Level 1 Screening Meeting Minutes

Project: US-20; Ashton to SH-87 JCT PEL

Subject: Screening

Date: January 20, 2022

SA1- A1

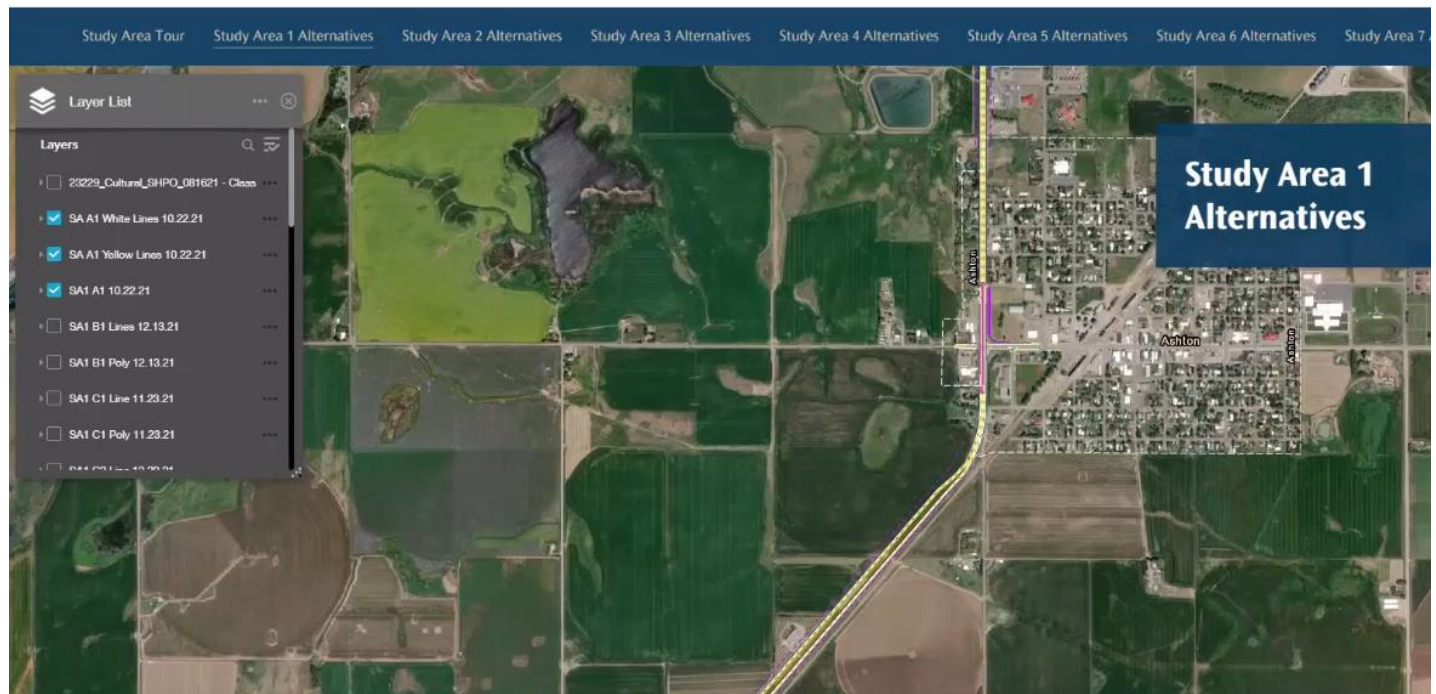
- Provides for the volume
- Would not inhibit community cohesiveness
- May inhibits long-term growth (hemmed in for future widening)
- Access concerns for design
- Safety concerns with access
- Mobility concerns due to reduced speeds and access points
- Horizontal curve may be a concern for speed
- Speeds approaching the intersection could become a concern compared to other alternatives
- Widening of the roadway moves road closer to existing businesses (loss of parking etc.)

Results of discussion: SA1- A1 moves forward (consider combining with the Chester to Ashton project)

SA1-C1

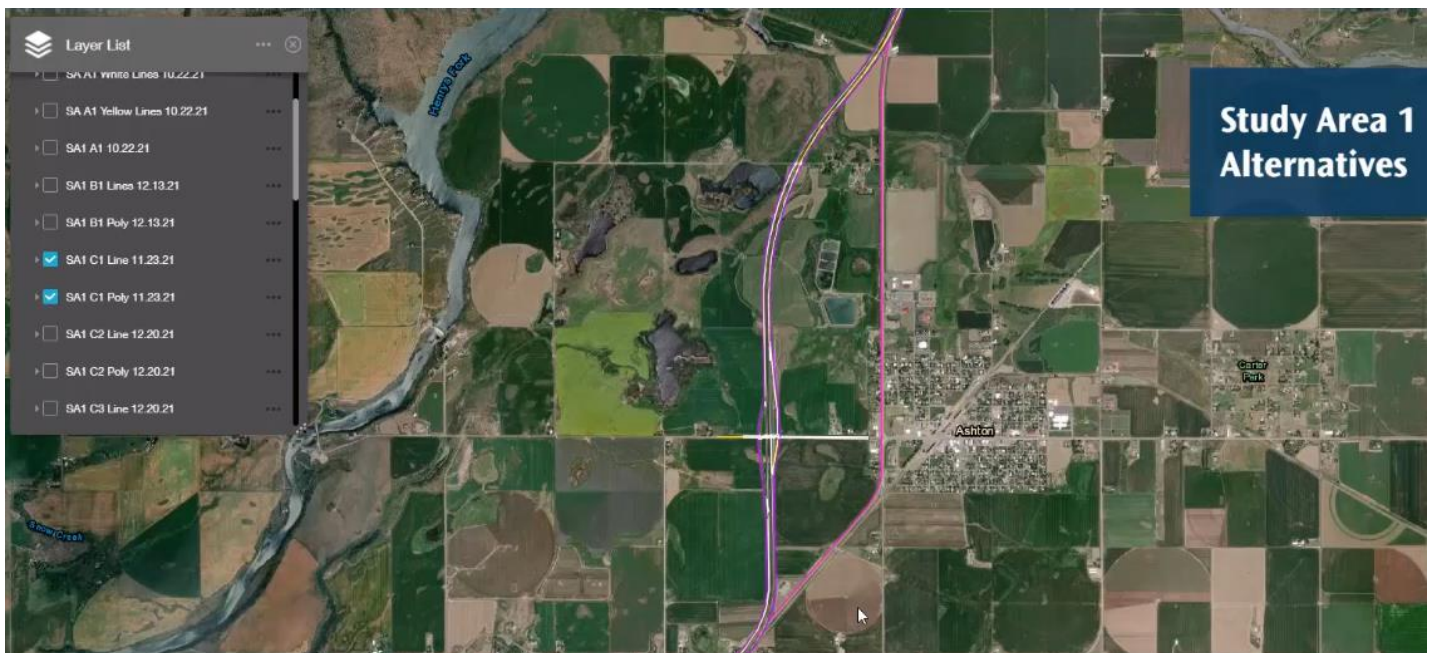
- Participants at public meeting liked it for ease and safety of access.
- Removes the problem for locals to cross US-20
- Fits with the local future planning for land use as described in public workshops
- West side landowners were not opposing
- Moves highway traffic away from schools
- Reduces thru traffic particularly freight traffic (improved safety)
- Allows the community to reduce speeds.
- Wetlands may be a concern.

Results of discussion: SA1- C1 moves forward

SA1-C2

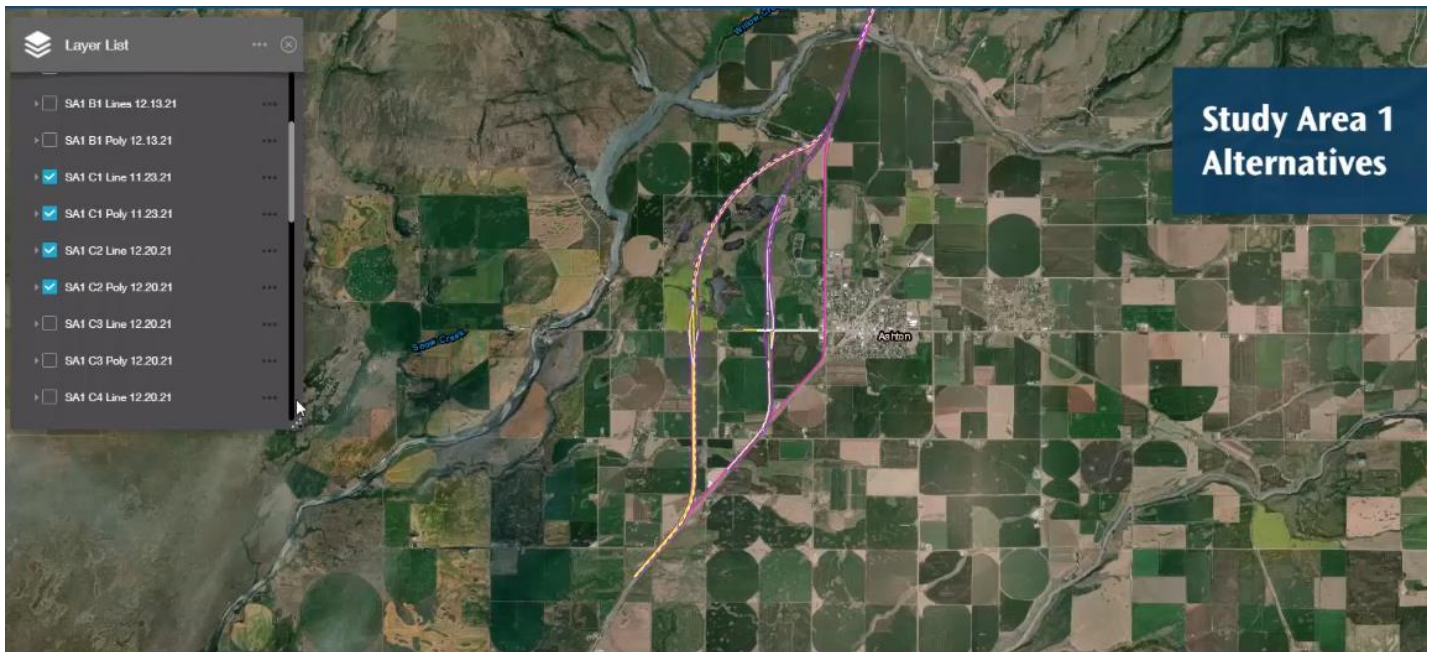
- At this distance there is more impacts, particular concerns about wetland impacts.
- An increased amount of roadway to build
- Causes development further that follows the US routes further from the community (possibly unwanted by the area residents)
- Travelers passing Ashton completely

Results of discussion: **SA1-C2 does not move forward**

SA2-A1

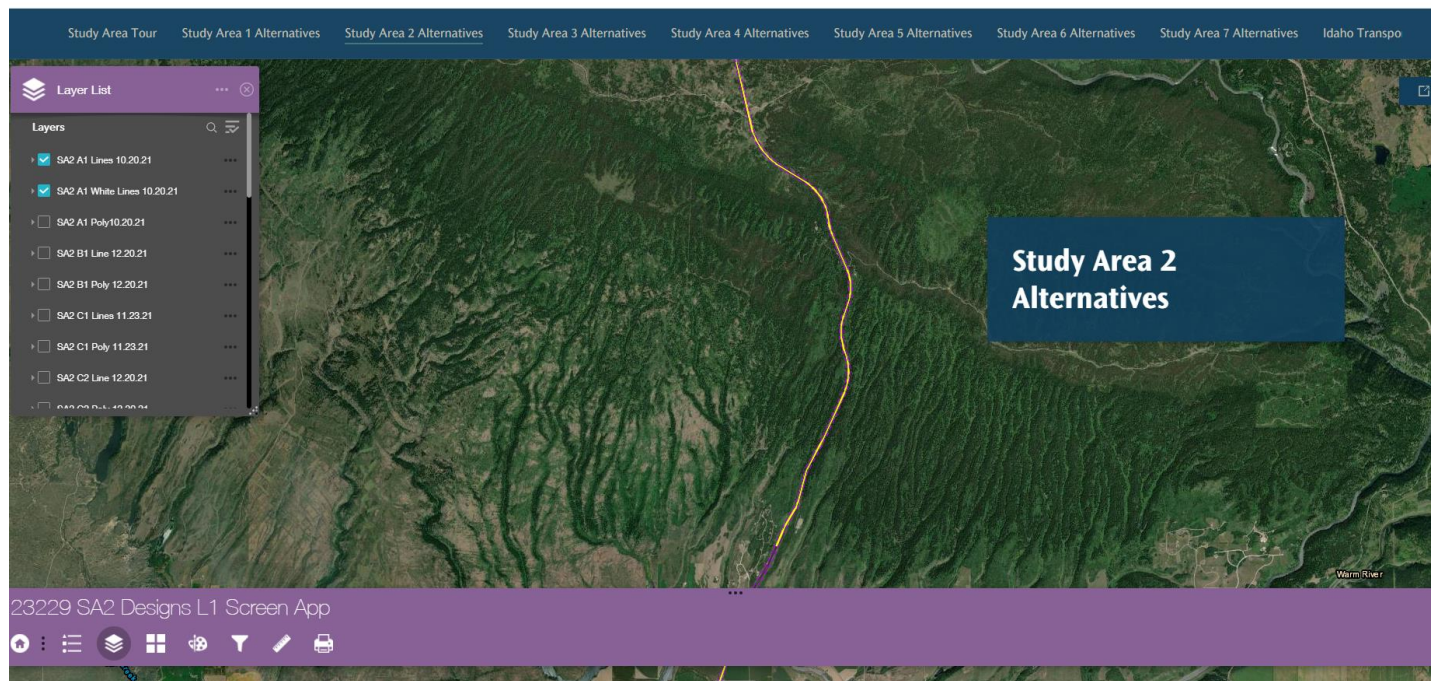
Discussion: Has potential to meet the needs. Much depends on topography for this alternative.

Results of discussion: SA2- A1 moves forward

SA2-B1

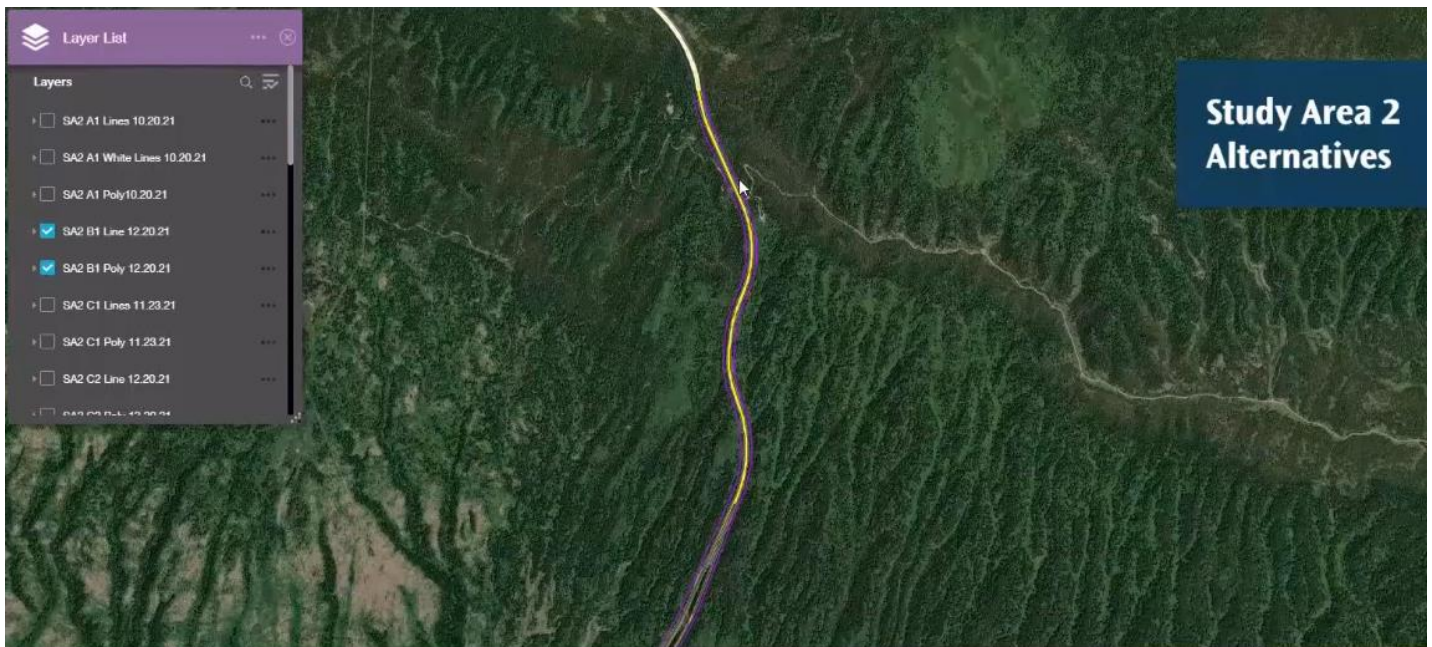
Discussion: Has potential to meet the needs. Much depends on topography for this alternative.

Results of discussion: SA2- B1 moves forward (may be in combination with SA2-A1)

SA2-C1

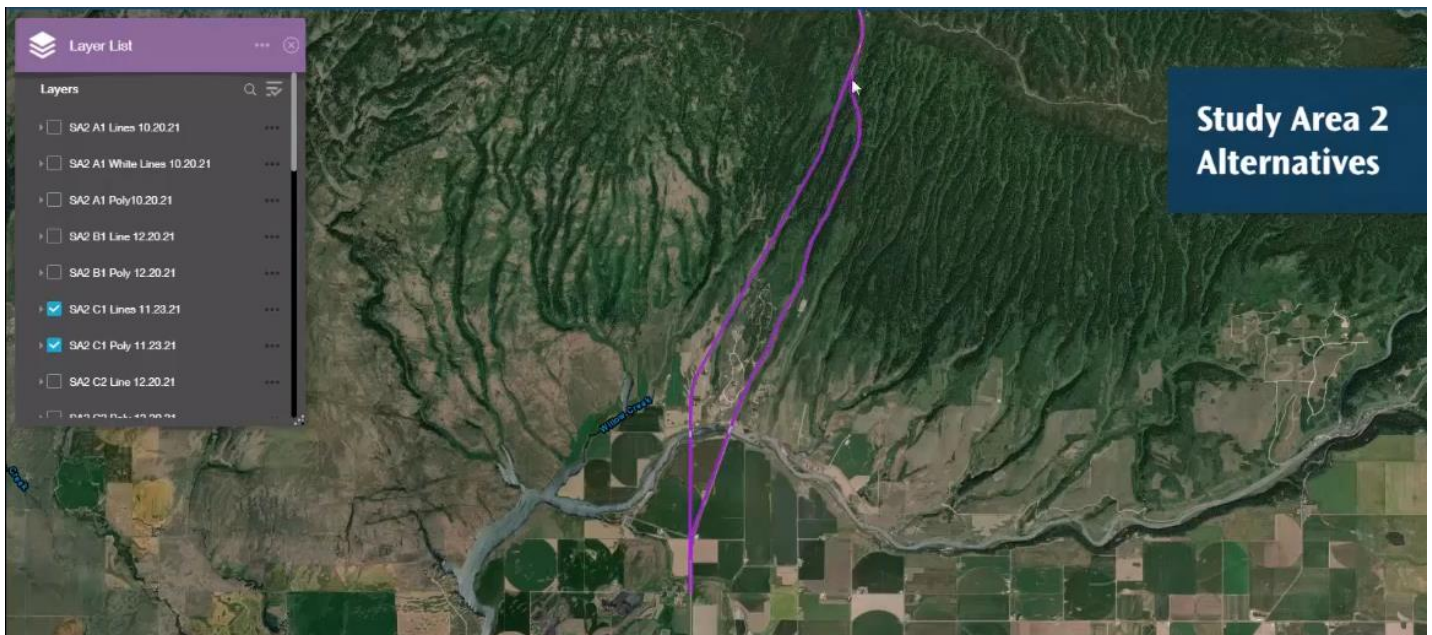
- Has potential to meet the needs. Much depends on topography for this alternative.
- Many similar concerns to other alternatives.
- May impact conservancy areas

Results of discussion: **SA2-C1 Moves Forward** Team should consider how it may combine with SA1-C4

SA2-C2

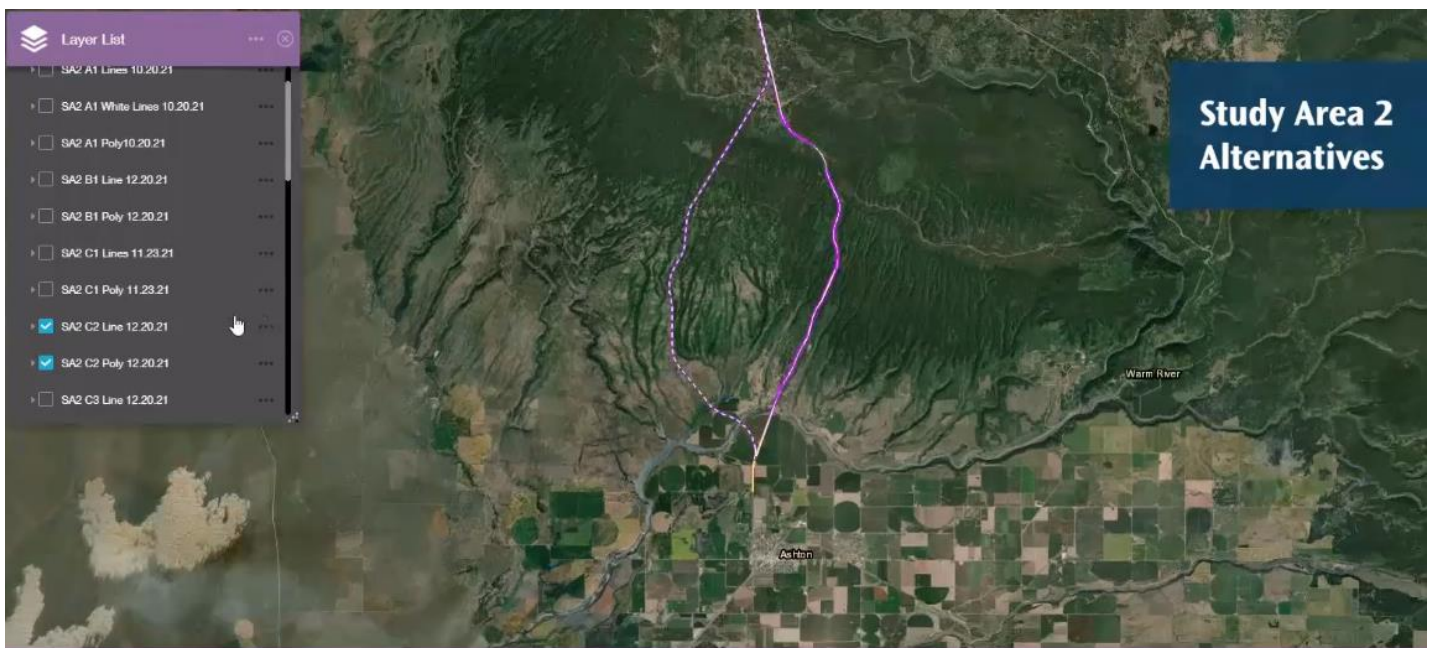
- Challenge to cross the caldera
- Will need an additional bridge crossing on the south
- Couplet options cause out of the way travel for emergency vehicles
- Rough terrain prevents emergency vehicle crossings.
- Old forest growth impact and deer migration

Results of discussion: **SA2-C2 does not move forward**

SA2-C3

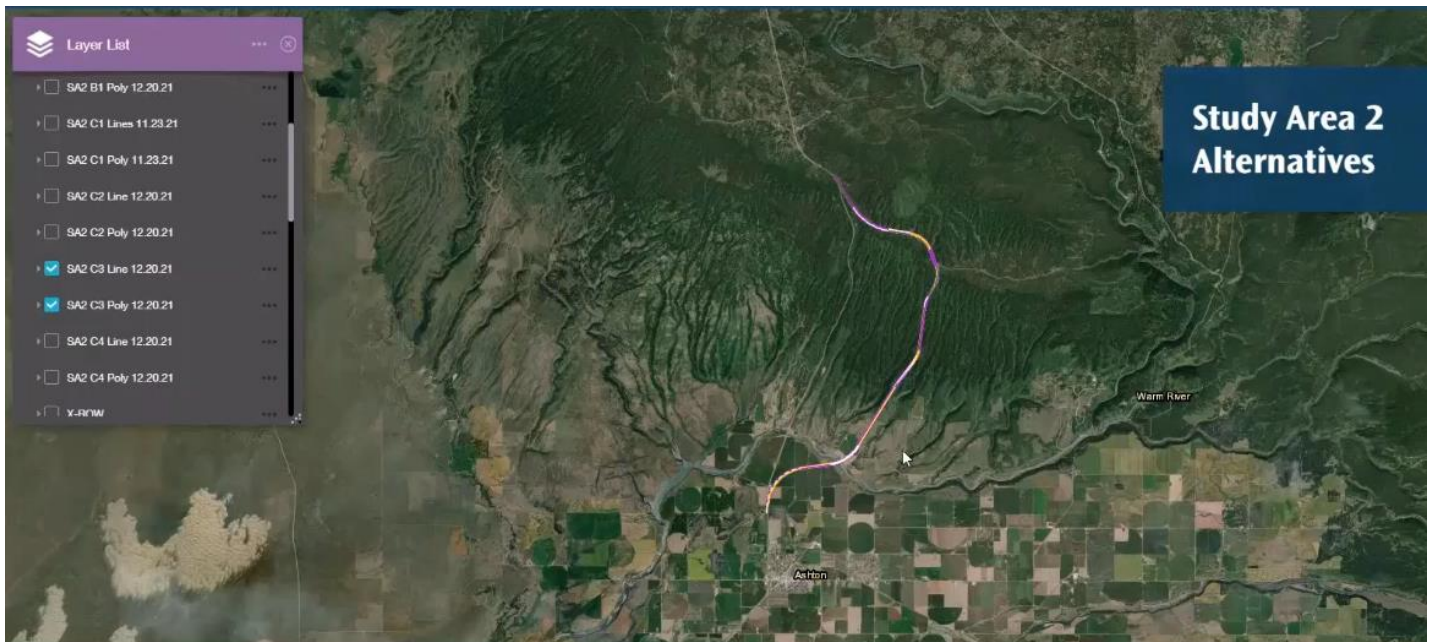
- Identified by the route-finding tool for easy grade
- Challenge to cross the caldera
- Current caldera crossing is the best selection (geological team presented this potential alternative and recommended staying with the existing crossing)
- Concerns were mentioned of old forest growth impact and deer migration
- There is potential a significant out of way travel distance
- Concerns about the EMS accessibility in the couplet scenario presents concerns

Results of discussion: **SA2-C3 does not move forward**

SA3-A1

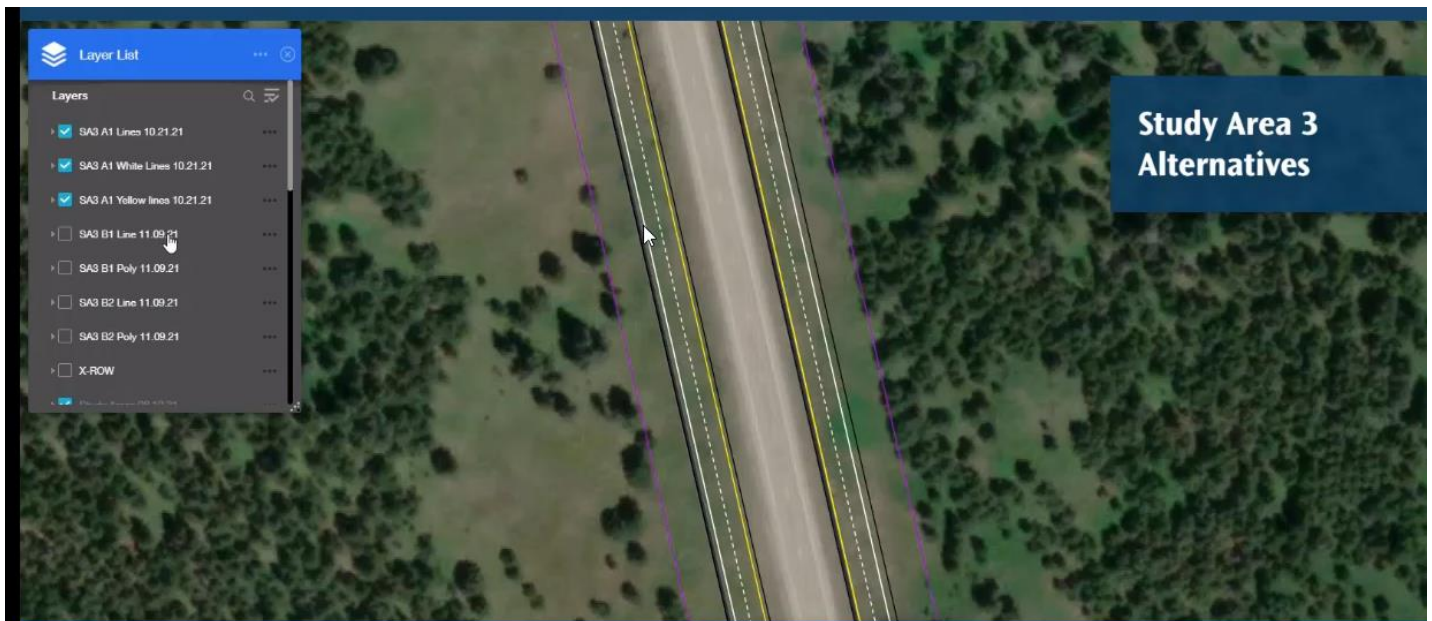
- Optimize A1, B1 and B2 design to fit obstacles and avoid impacts. Combine all three areas into one.
- As a combined alternative the western limits would be defined by the proposed ROW for SA3-B1 and the eastern limits would be defined by SA3-B2.
- Construction traffic control, environmental impacts and Forest Service polygon impacts should be considered as the alternative is refined.

Results of discussion: SA3- A1, B1 & B2 move forward combined (east and west limits)

SA5-B3

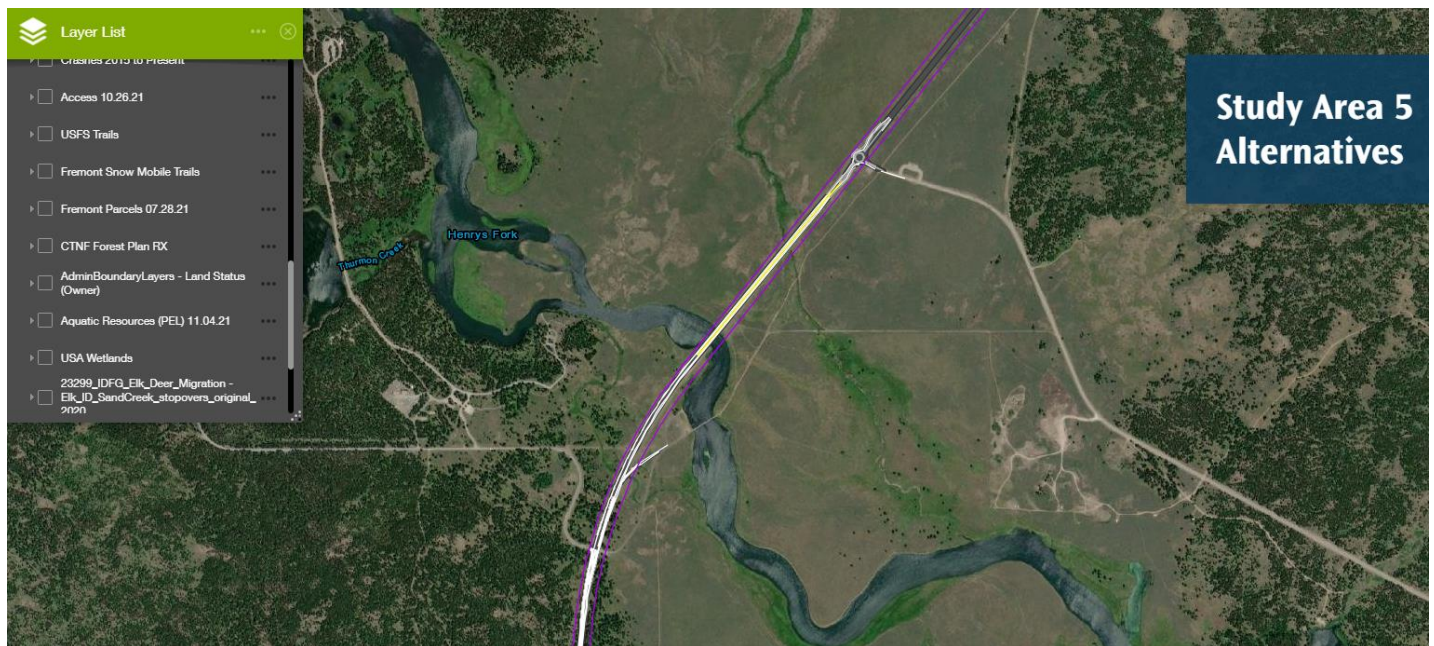
- Concerns about the roundabout traffic backing up on US-20 in the peak seasons and causing rear end collisions
- Driver expectations and consistency on the corridor are not conducive to a low-speed intersection
- This is a very foggy area.

Going forward possibly consider these intersections generically as a high-capacity intersection needed instead of choosing an intersection solution in the is phase.

Results of discussion: **SA5- B3 does not move forward** Elements of the alternative may be considered as a part of other alternatives, however, the alternative

SA4-A1

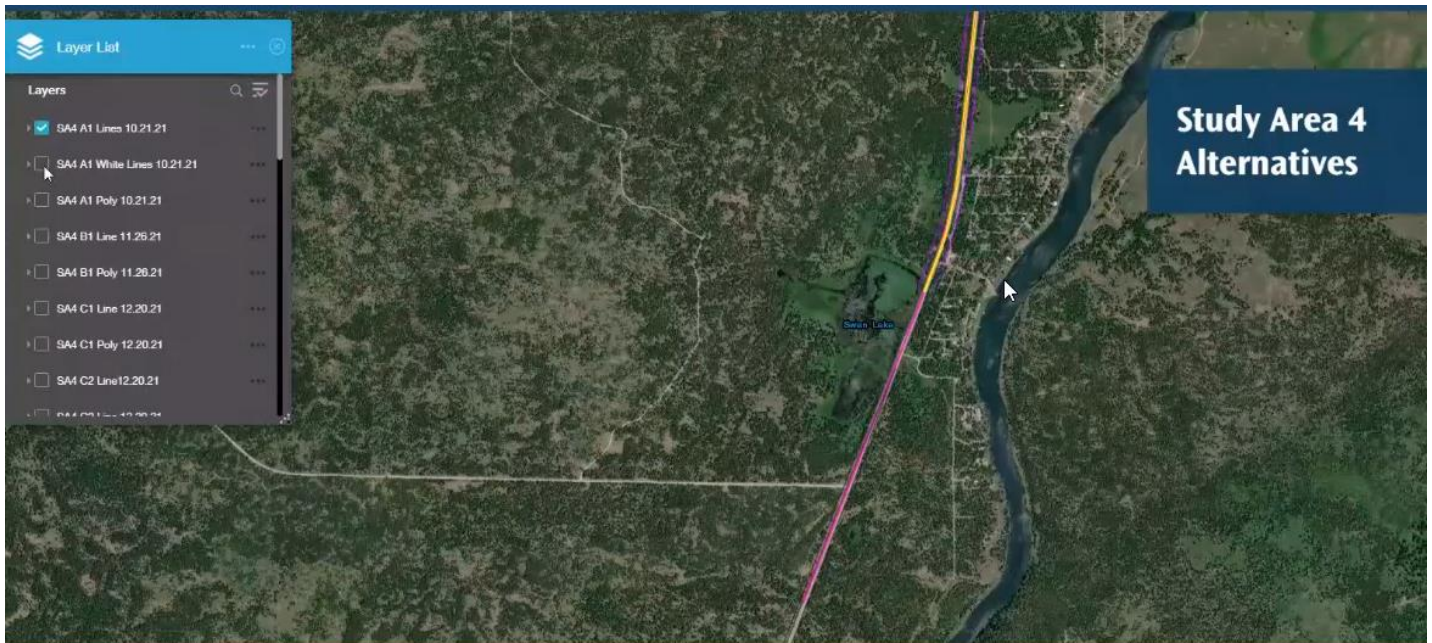
- May benefit from considering a frontage road on the east side
- Sensitive areas on each side of the road with the Swan Lake area on the west and the Pine Haven on the east
- Difficult to maintain the design speed
- Difficult to fit in the frontage roads

Results of discussion: SA4-A1 & B1 combine and move forward
